WCAP-14575-A

# **Aging Management Evaluation for Class 1 Piping and Associated Pressure Boundary Components**

UNITED STATES  
NUCLEAR REGULATORY COMMISSION  
WASHINGTON, D.C. 20555-0001

SUBJECT: ACCEPTANCE FOR REFERENCE IN THE GENERIC LICENSE RENEWAL  
PROGRAM TOPICAL REPORT ENTITLED, "LICENSE RENEWAL EVALUATION:  
AGING MANAGEMENT FOR CLASS I PIPING AND ASSOCIATED PRESSURE  
BOUNDARY COMPONENTS," WCAP-14575, REVISION 1, AUGUST 1996

**Figure 4-1 Flow Chart for Fatigue, AMP-3.3 (for ASME designs) [Ref. 42]**

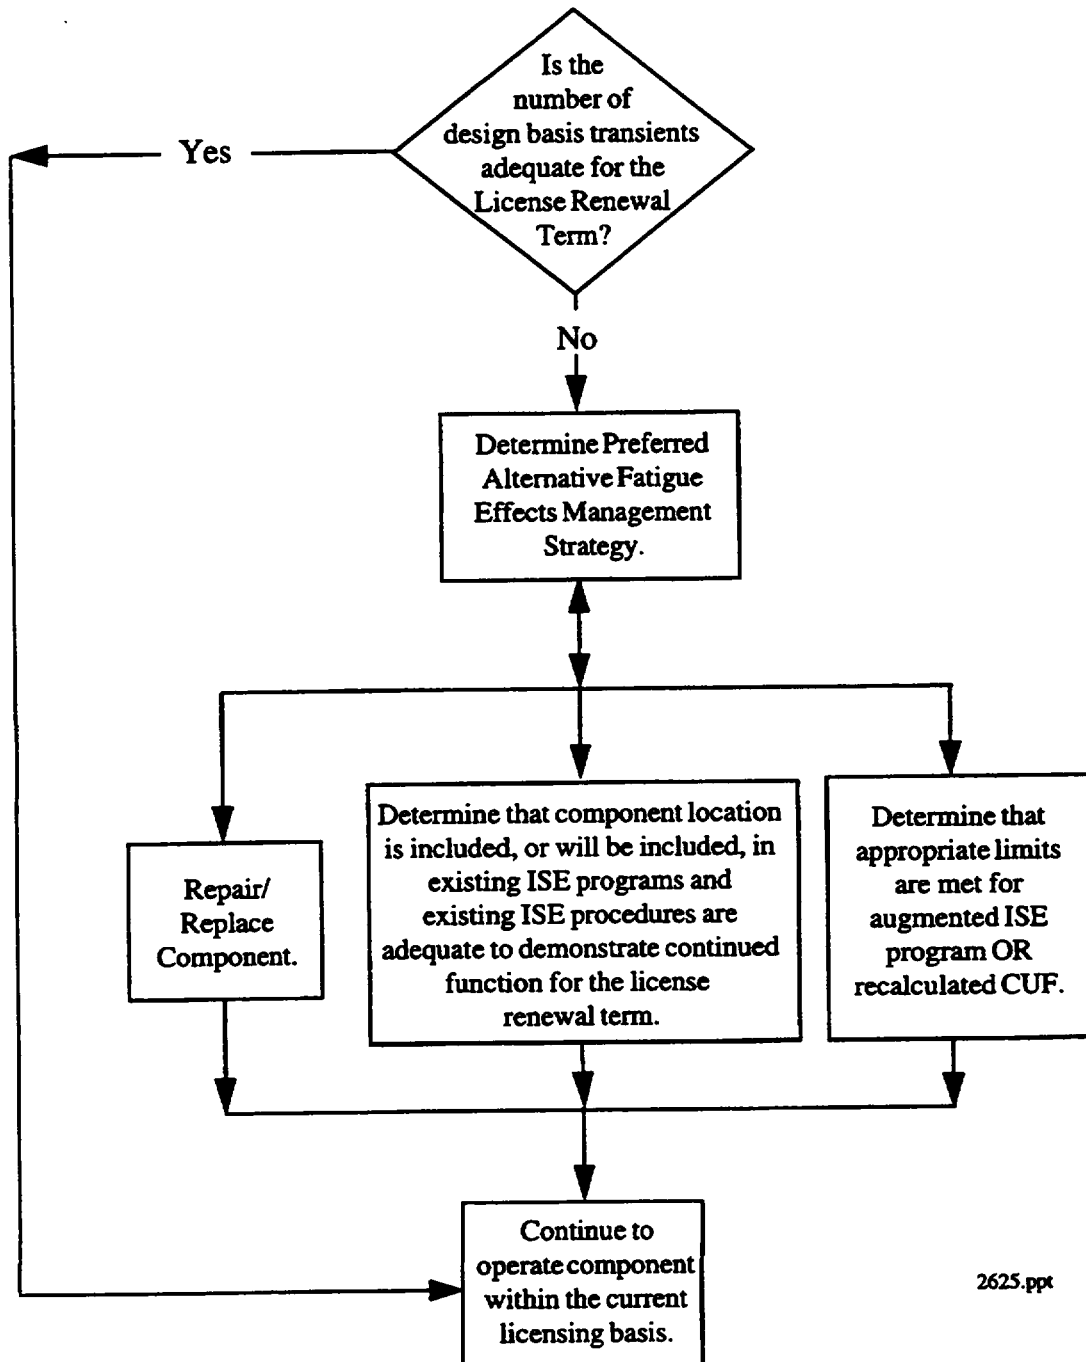
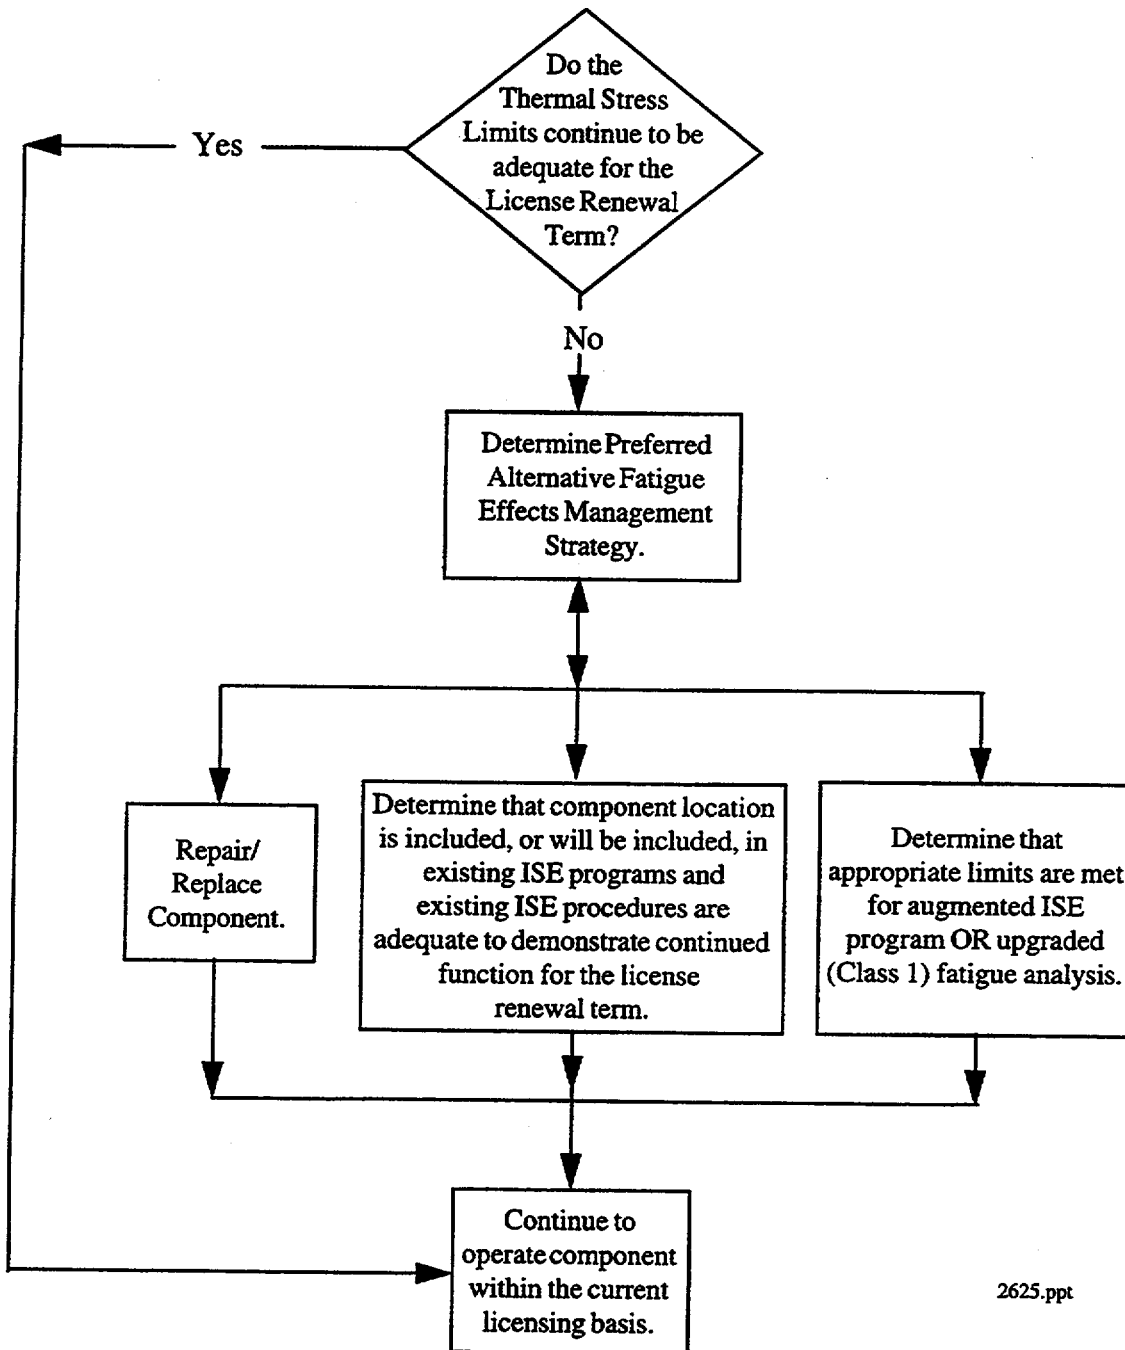
1b. Section 3.3.2 contains a description of a fatigue assessment of B31.1 piping design. The final sentence concludes, "Based on the successful operating history of fossil plants (using the B31.1 approach) and the high cost of evaluating these stresses with a detailed fatigue analysis, this was considered to be an acceptable approach for nuclear plants." Explain what is intended by this sentence. Also, explain how this conclusion was used to develop the aging management program for fatigue.

The appropriate changes to sections 3.3, 3.4, 4.2.1, Tables 3-2 thru 3-16, 4-4, 4-5, 4-6, and 4-7, and Figures 4-1 and 4-2 will be made to incorporate the revised industry position that considers environmental effects.

The aging management program for fatigue is based on the proposed industry position on fatigue evaluations for license renewal and the B31.1 code requirements. Section 4.2.1.2, "Process to Qualify Fatigue for B31.1 Piping Components" applies to plants that have the B31.1 code included in the current licensing basis.
